These changes are recommended for ALL HORIZON RAMdisks and are compatible for use with the TI99/4a or Geneve.

1. RESET on power-up

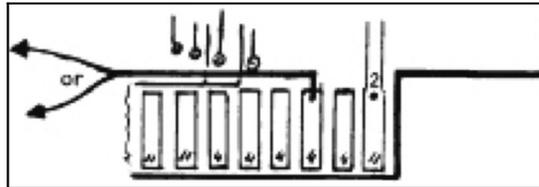
This change allows the computer to reset the HORIZON during the CPU power up cycle. The reset feature, as TI designed it, does provide a reliable method to hold the HORIZON in the shut-off state until the PE-Box voltage has been on long enough to stabilize. The modification consists of the removal of one diode, one resistor and one capacitor. These parts are replaced by one wire from pin 6 of the card-edge connector (bottom edge of ramdisk card) to the positive side of the capacitor location.

HORIZON serial numbers below 100:

Remove C8, CR2 and R2. Connect wire to front (or left) hole of C8 location.

HORIZON serial numbers above 100:

Remove C1, CR3 and R5. Connect wire to + (positive) side of C1 location.

Connect other end of wire to pin 6 of card-edge, i.e., the 3rd lead from the right on the COMPONENT side of the PC board.

2. DISABLE SWITCH

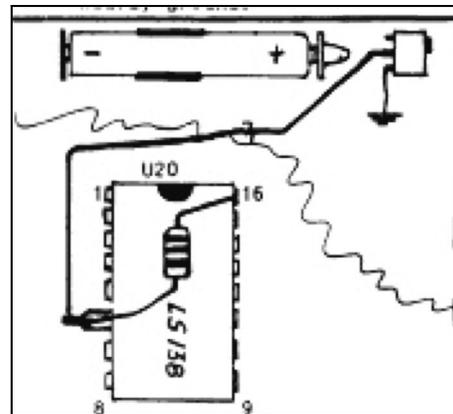
This modification provides a method to turn off (or hide) the HORIZON from the rest of the system. This switch allows you to turn off the ramdisk in the event of a system crash when the computer locks up. With the card turned off, you can power up the console and PE-Box, turn the card back on and proceed to re-load the operating system. No need to remove the batteries to erase the contents and in most cases the files may be recoverable. Other reasons for "hiding" the card could be a conflict between the ramdisk and a program you want to run or you may wish to keep the kids out of it.

The mod is simple: We remove the voltage from pin 6 of U20 (serial 1999 and below) or

U20A (HRD+ ,2000 and up) and reconnect it via a resistor (1k-10K will do) thru a SPST switch to ground. Closing the switch pulls the pin low and shuts off CRU access at U20

Bend pin 6 of the chip out, attach enough wire to reach the switch and connect the resistor from this pin to 16 of the same chip. Run the other end of the wire to the switch.

NOTE: The HRD+ circuit board on cards with a serial number below 1999 required stacking of U20. Attach the wire and resistor to the top chip's pin 6 and cut off the bottom end.
